HARTZELL PROPELLER INC.

ALERT SERVICE BULLETIN

HC-ASB-61-313

Propeller - Counterweight Slug Bolt Inspection

Counterweight Slug Attachment Bolt Identification
Figure 1

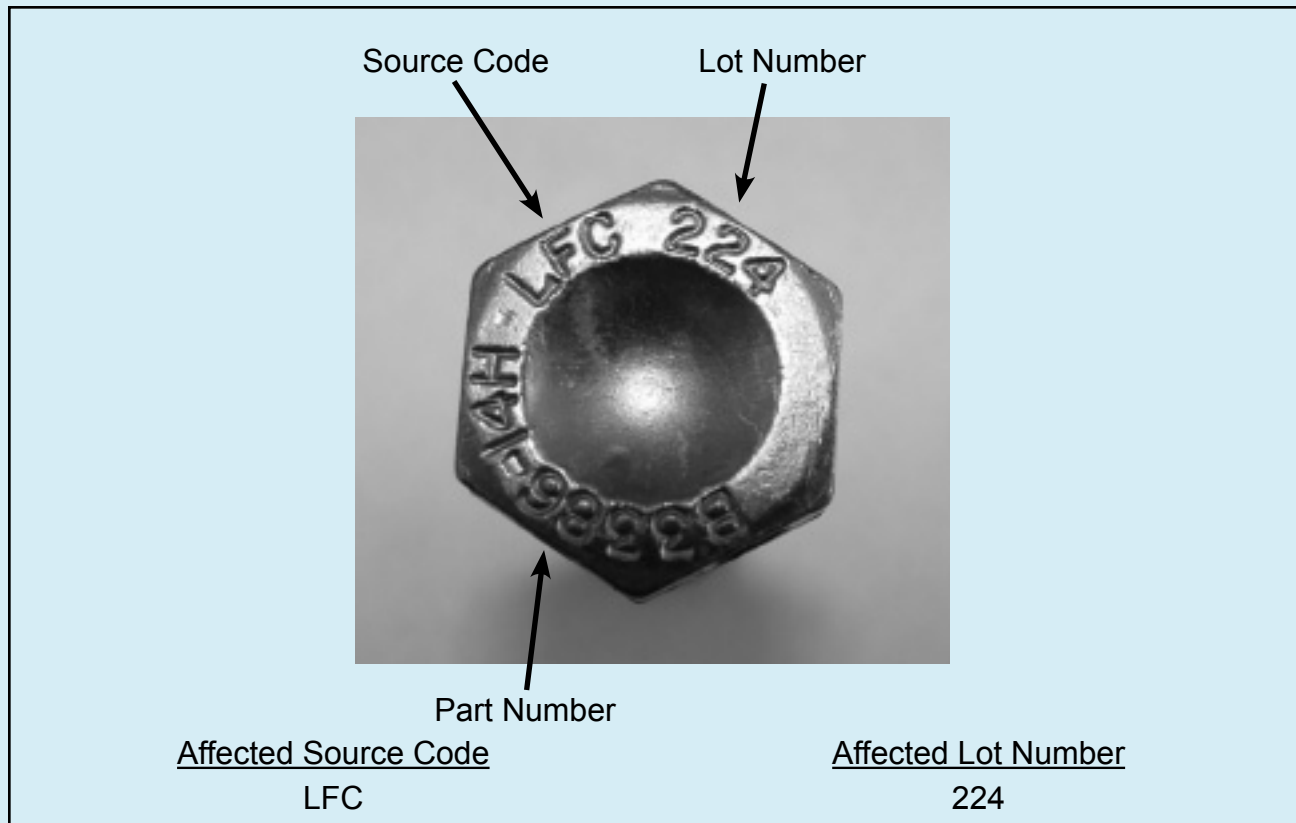
- Consolidate Table 1 information listing affected models.
- Remove redundant illustration from Figure 1.

- (a) Inspect each B-3386-14H counterweight slug attachment bolt on the propeller for the affected LFC manufacturing lot. See Figure 1.
 - 1 Bolts marked from another source code or lot number other than 224 are not affected by this Alert Service Bulletin.
 - 2 If only one counterweight slug attachment bolt on a counterweight slug is from the affected LFC manufacturing lot 224, both bolts may require replacement.
 - 3 Visually inspect all LFC manufacturing lot 224 counterweight slug attachment bolts for the following obvious signs of failure:

- (1) Inspect each B-3386-14H counterweight slug attachment bolt for the affected LFC manufacturing lot number. See Figure 1.
 - (a) Bolts marked from another source code or lot number other than 224 are not affected by this Alert Service Bulletin.
- (2) Immediately quarantine all affected bolts.
